FRIGIDAIRE

2000 SERVICE UPDATE INFORMATION

New Front Axle and Frame supports on 2000 LT

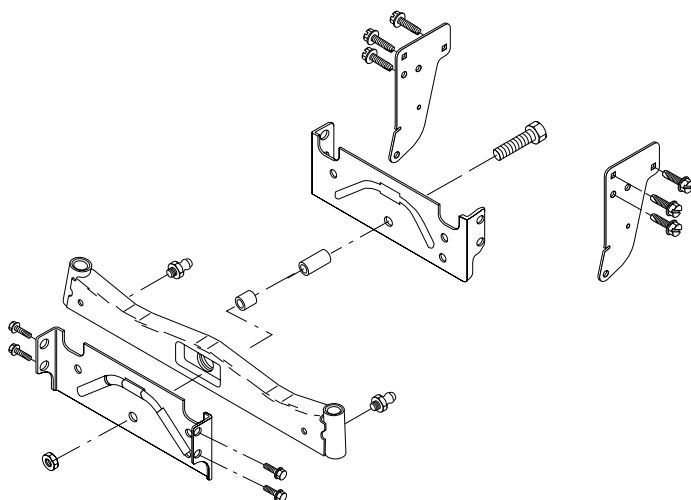
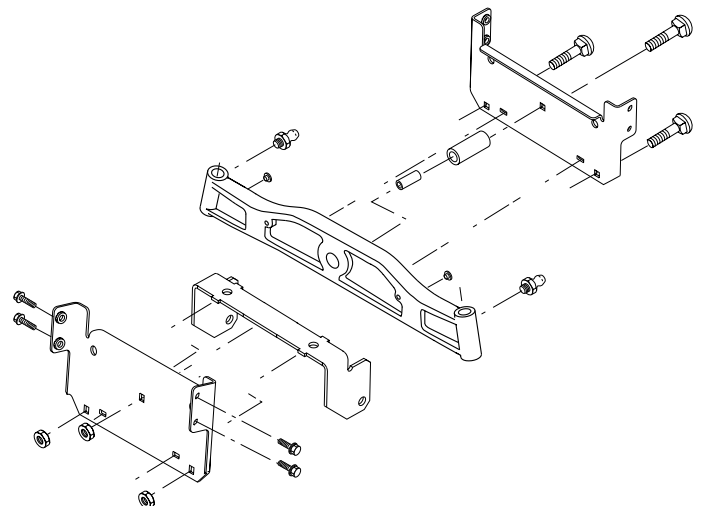
Changes to the axle area will give several benefits. The dimension for the axle channel will be fixed both above and below the axle. This will keep the axle channel from being able to spread below the axle. With this area more firmly supported, we will see less steering play as the Lawn Tractor is used;S and the steering will remain tight for longer service. The changes in this area and the spindles will also result in up to a 20% reduction in turning radius. The mower suspension points will be from brackets tied to the bottom of the axle channel supports.

Browning shield on 2000 Lawn Tractors

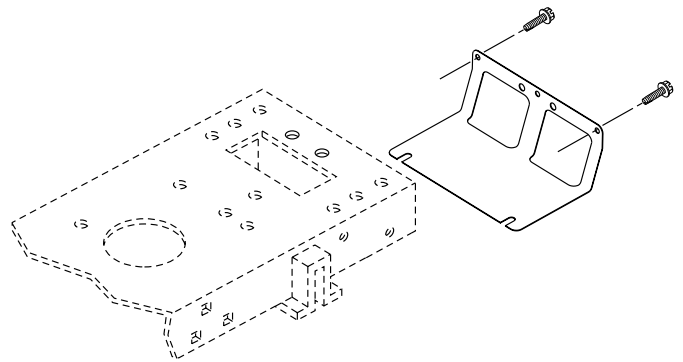
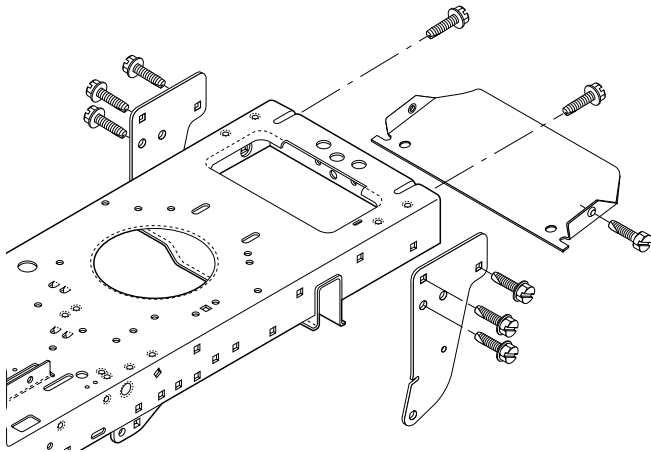
Because of changes to the front axle supports, the Browning Shield will change on Model Year 2000 lawn tractors.

New Tractor Electrical Connector at Engine

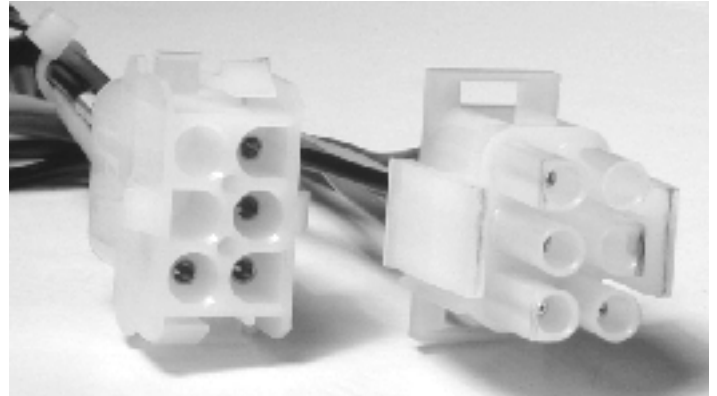
- Eliminate the 'pigtail' currently needed on many harnesses
- Reduce the number of different harnesses needed
- Provide the same connector for engines from all manufacturers

New Cable Clutch for Manual Engagement Mowers in 2000

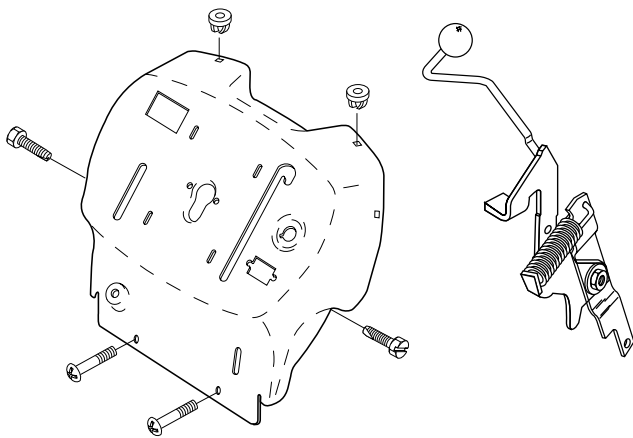
- Longer belt life due to softer engagement and additional idler travel for disengagement.
- Engagement requires 18% less force than mechanical clutch.
- Eliminates welded engagement lever.
- Puts interlock switch in service accessible location.
- 42" mower with cable clutch uses existing 144959 Mower Belt

New NORAM Clutch for manual engagement

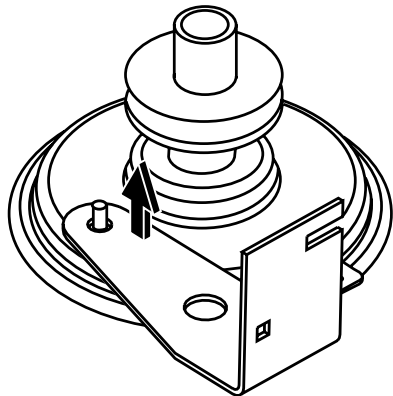
The NORAM Clutch will be used on center rear discharge mower decks. It will use the same deck assembly and drive belt as models that use an electric clutch.

The NORAM Clutch has the advantage of being smoother than an idler pulley clutch and less likely to kill the engine on deck engagement.

The bolt holding the NORAM Clutch to the crankshaft must be torqued at 50 Foot Pounds like the electric clutches.

The anti – rotation bracket must be in place on the anti – rotation clutch bolt in operation or damage can occur. The Noram Clutch uses the cable clutch mechanism shown on pages 14 and 15.

New on Rear Tine Tillers for model year 2000....

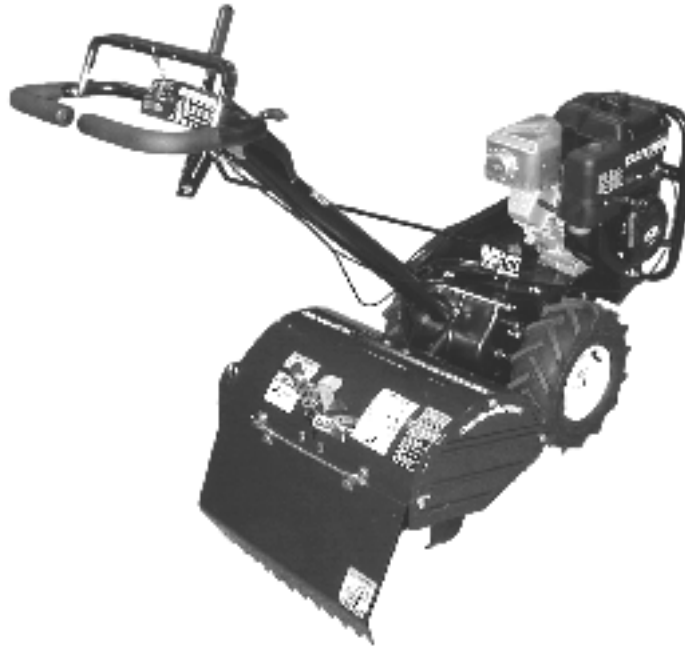
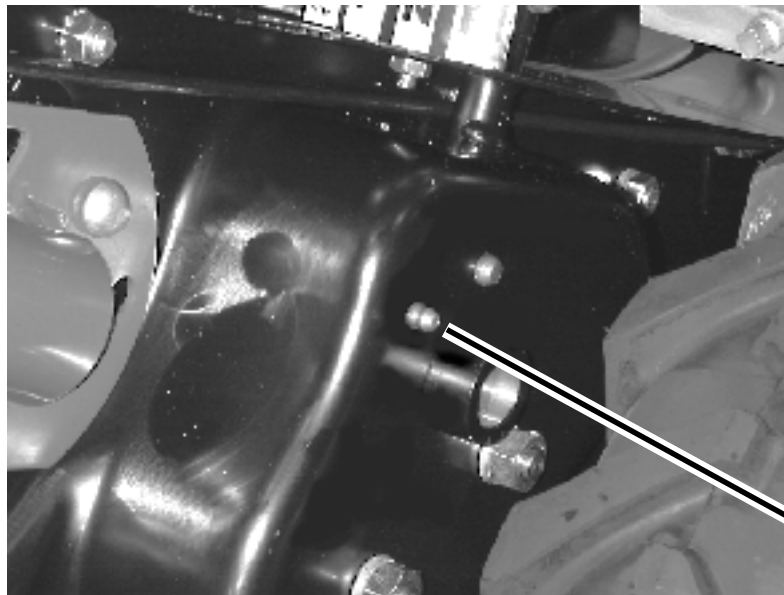
There will be a grease fitting added on the right side of transmissions.

It is recommended to customers to add one squirt of EP-1 Grease for every 10 hours of use, or when the tiller is stored at the end of the season.
